Strategic Housing Development (SHD) at Former O'Devaney Gardens, Dublin 7

Bartra ODG Limited (Applicant)

PLANNING STATEMENT/ RESPONSE TO ABP STAGE 2 OPINION

May 2021

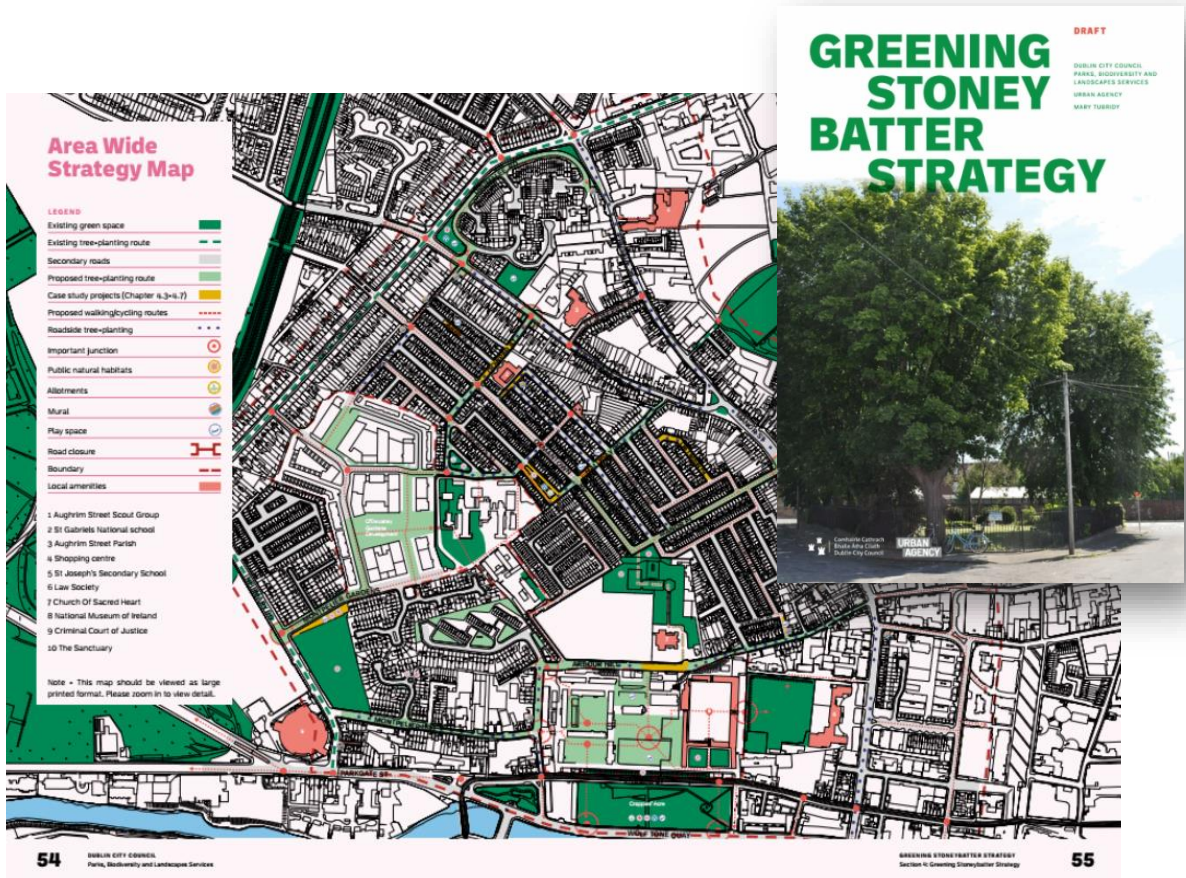
The further consideration of these issues may require an amendment to the documents and/or design proposals submitted relating to density and layout of the proposed development.

Following the Stage 2 submission, further consideration was given to all site interfaces by the project architects. This included the eastern and northern connections identified above as well as the Block 2 interface with North Circular Road and the Block 8 interface with Montpelier Gardens.

The overall rationale is provided in Section 3.2 - *Site Movements and Connections* - of the Architect's **Design Statement** [OMP], with supporting cross-sections, studies and visual aids. Section 4.3 – Permeability and Legibility – also addresses this issue and Section 3.4 relates to Interface with St. Bricin's.
